**TOWN OF BROOKLYN
PLANNING AND ZONING COMMISSION
Regular Meeting Agenda
Wednesday, August 5, 2020
6:30 p.m.**

Engineering Plan Review Pertaining to Proposed Gravel Excavation

PAUL R. LEHTO
(RIVER WALK DRIVE)
BROOKLYN, CT
(July 14, 2020)

SHEET 3 OF 5 – SITE DEVELOPMENT PLAN NO. 1

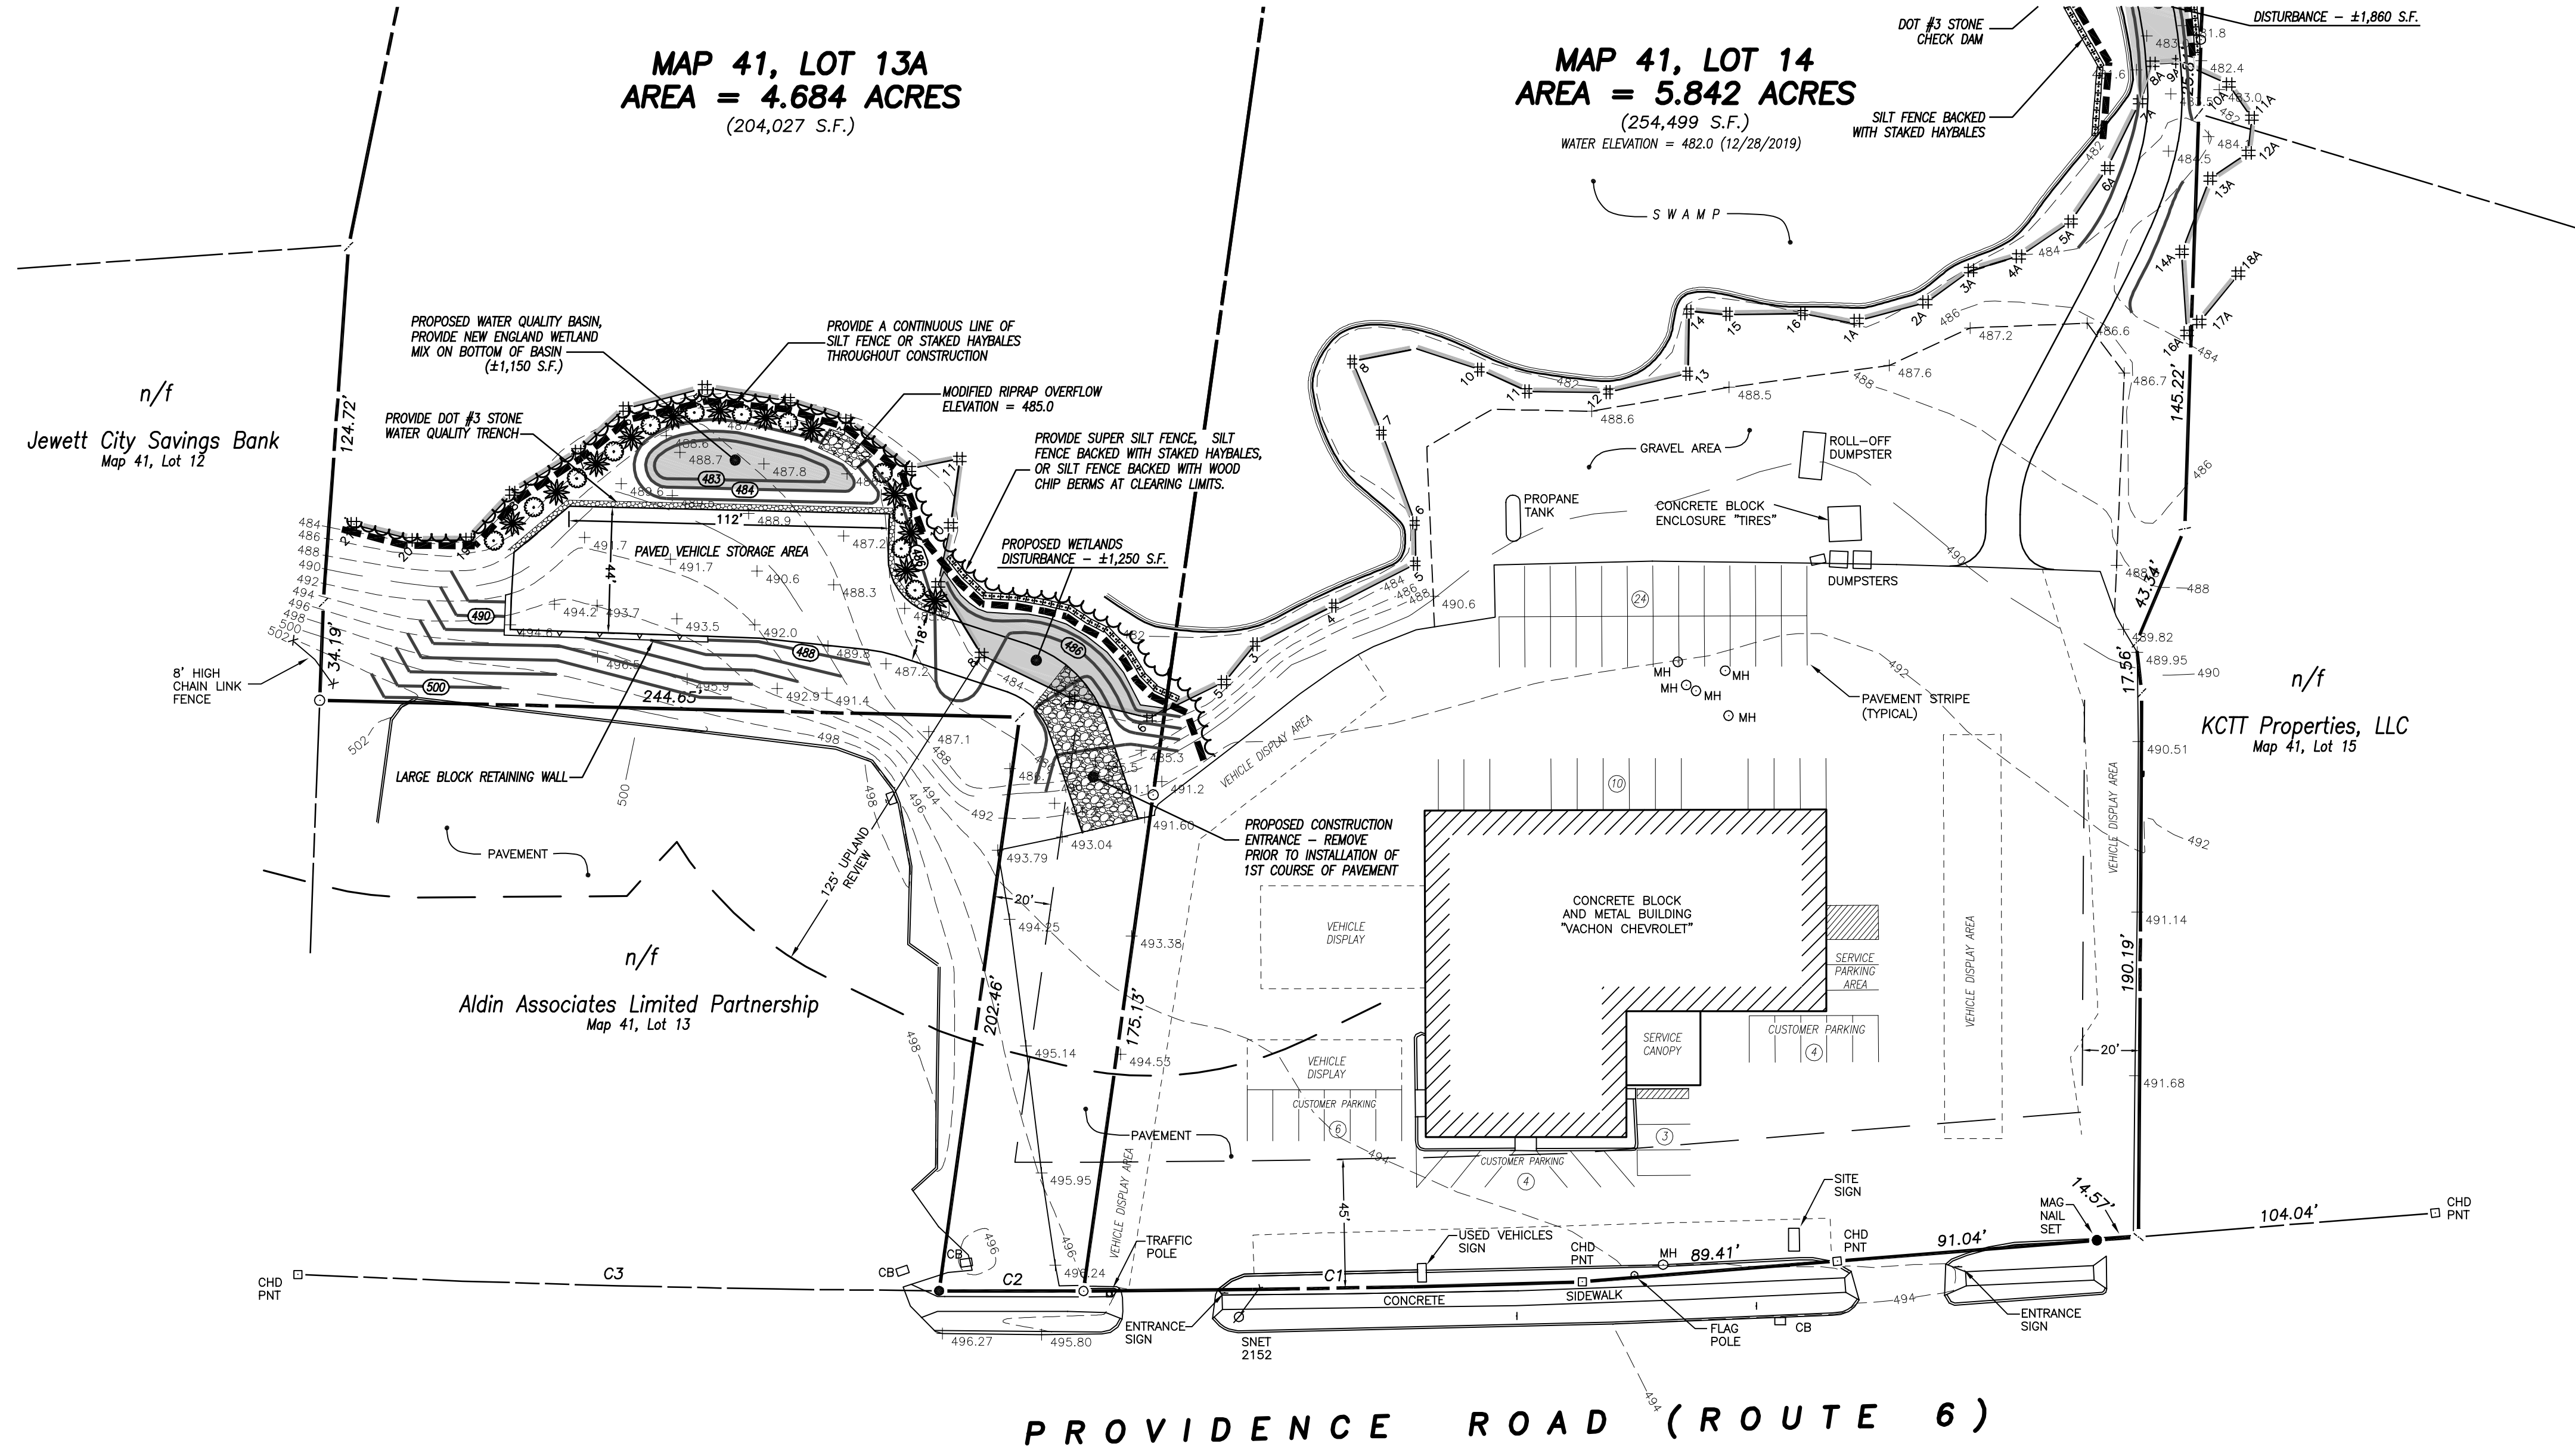
1. A construction entrance symbol is drawn at the entrance to the new "paved vehicle storage area." However, a note should be included to indicate that this will be removed at the time the first course of paving is installed for the vehicle storage area. Additionally, it would be helpful for this explanation to be included in Note 17 under "Development Schedule/Sequence of Operations" that appears on Sheet 5 of 5 of the plan set.
2. The note "Silt Fence Backed with Staked Haybales or Wood Chip Berms" should read the same as the note on Sheet 4 of 5, "Provide Super Silt Fence, Silt Fence Backed with Staked Haybales, or Silt Fence Backed with Wood Chip Berms at Clearing Limits," for consistency.

1. A note has been added to the plan to direct the contractor to remove the anti-tracking construction entrance prior to installing the first course of pavement. This has also been noted on sheet 5 of 5 in the development schedule/sequence of operations.
2. The note "silt fence backed with staked haybales or wood chip berms" has been modified to read the same on all sheets.

SHEET 4 OF 5 – SITE DEVELOPMENT PLAN NO. 2

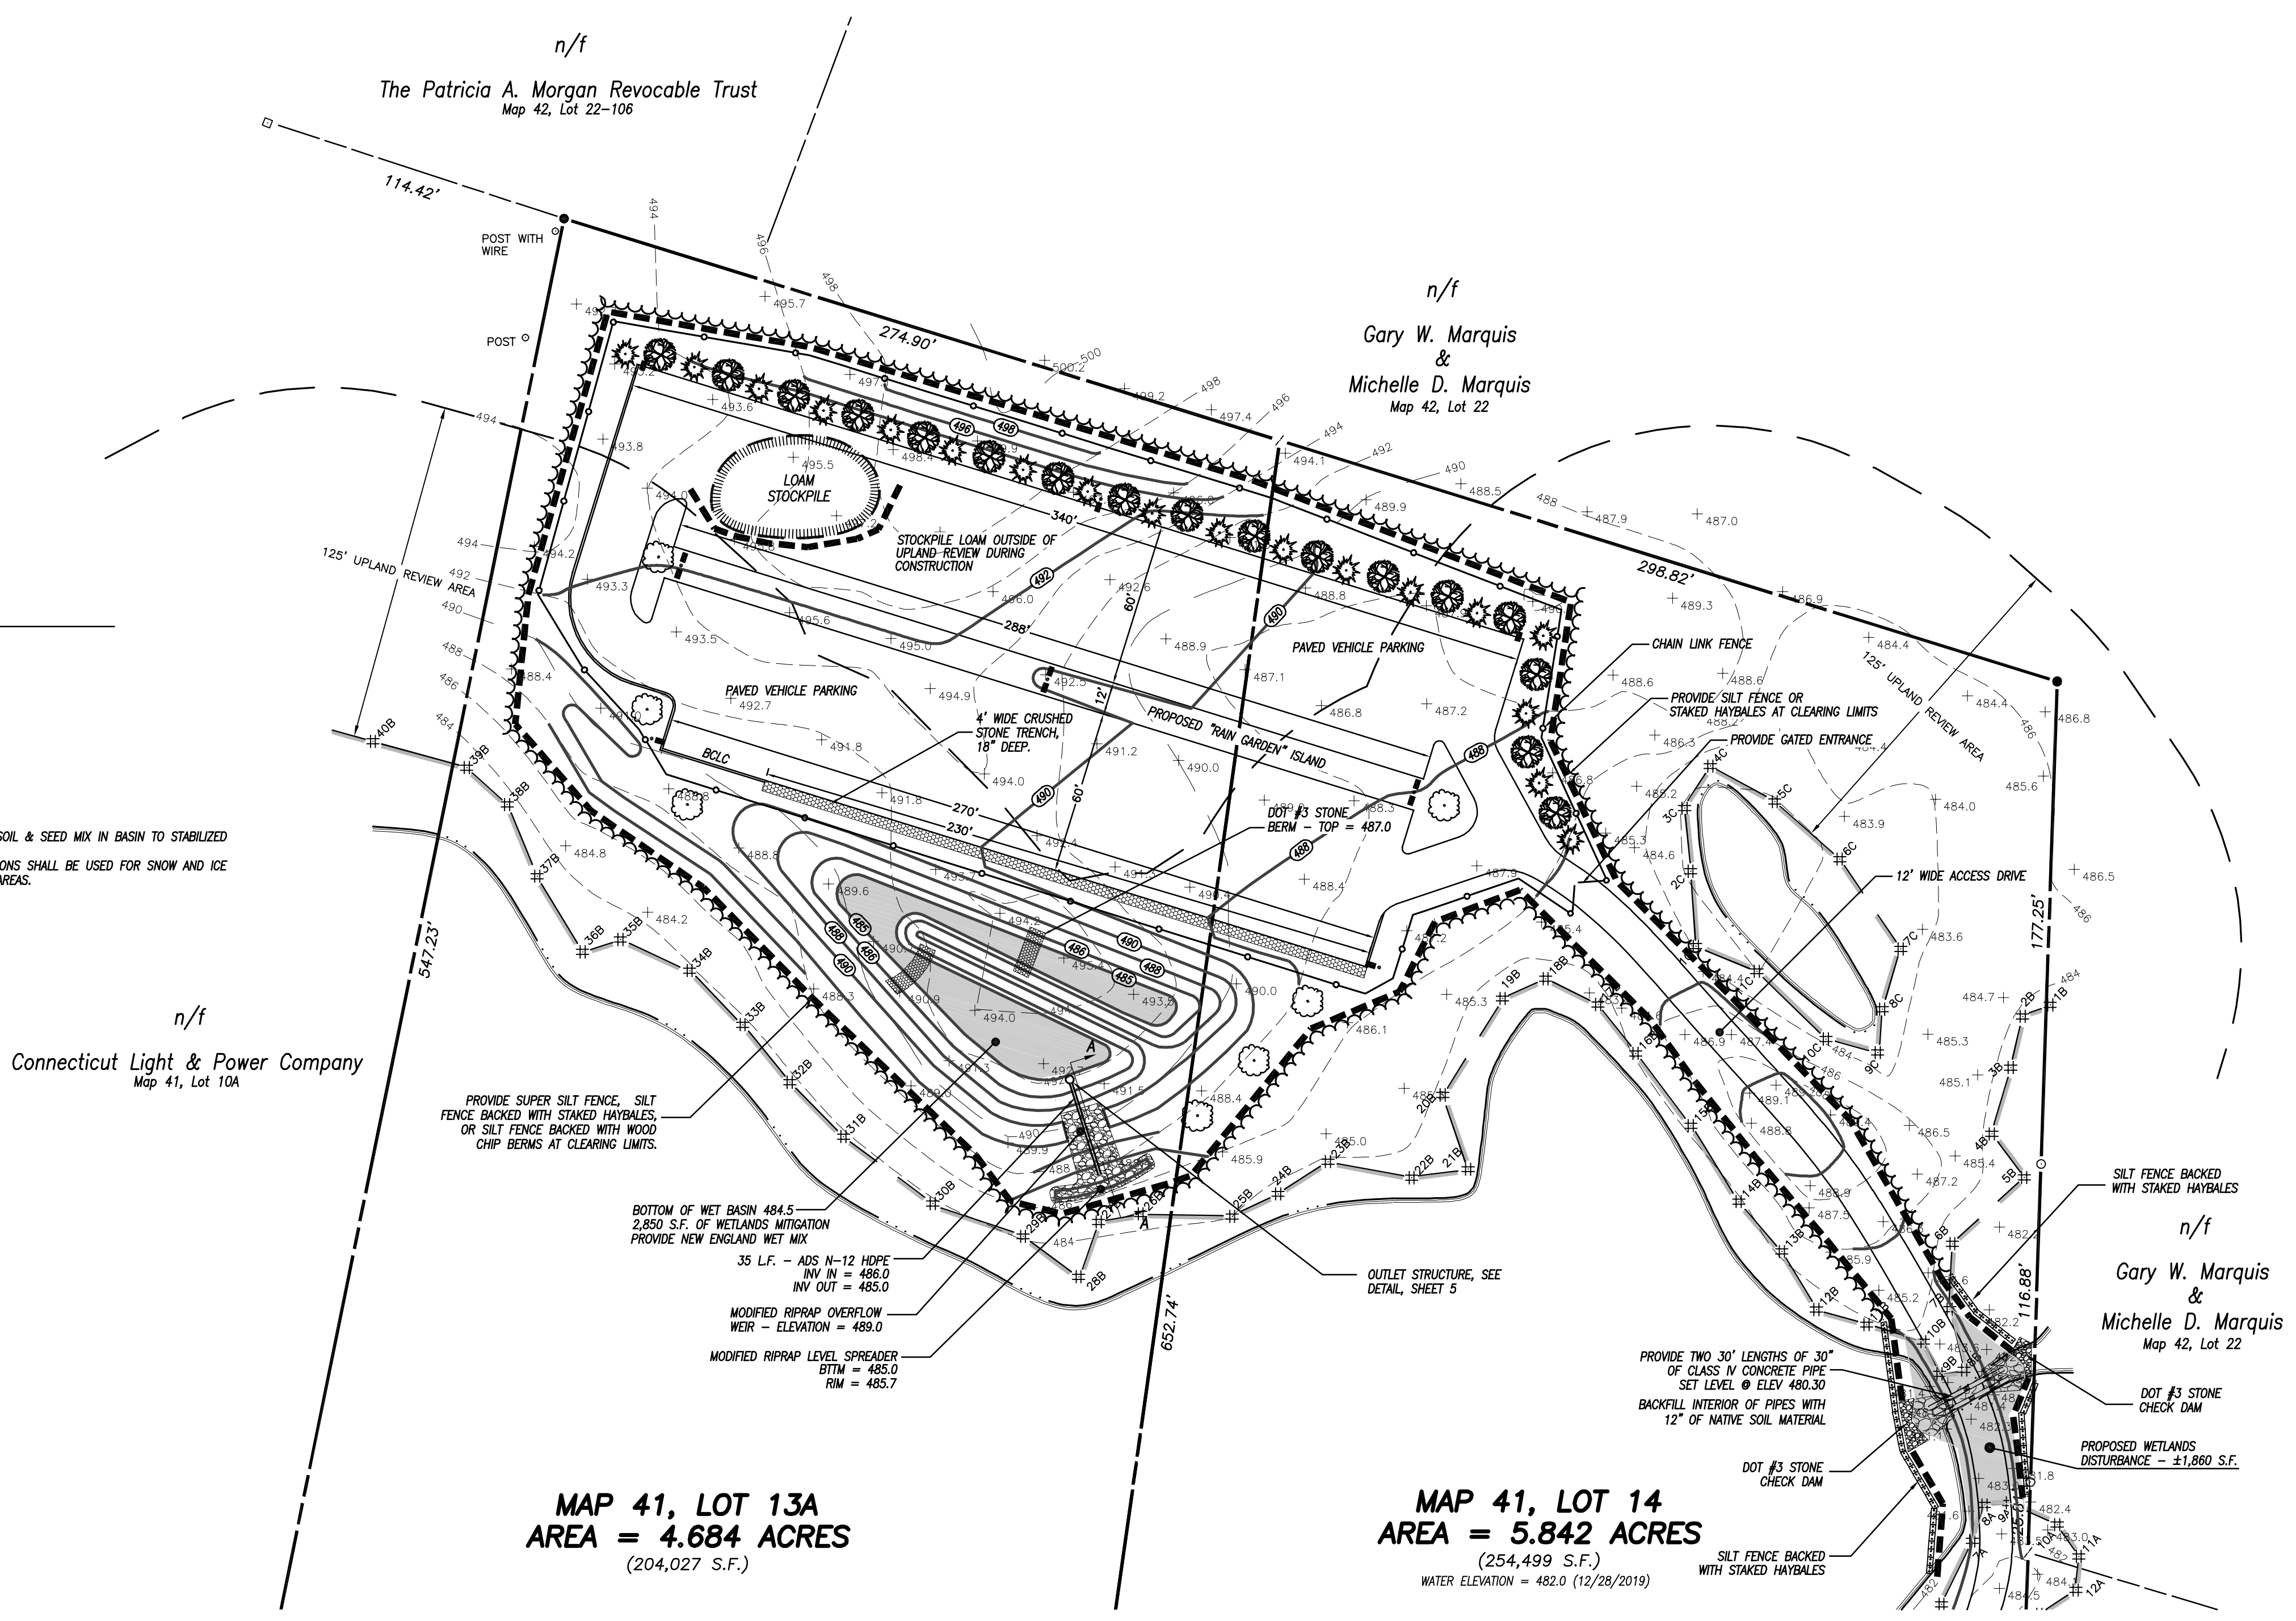
3. Snow will be stockpiled at the top of the slope adjacent to the proposed stormwater basin. Sheet 5 of the plans specify that no salt or chemical applications for snow removal shall be used.
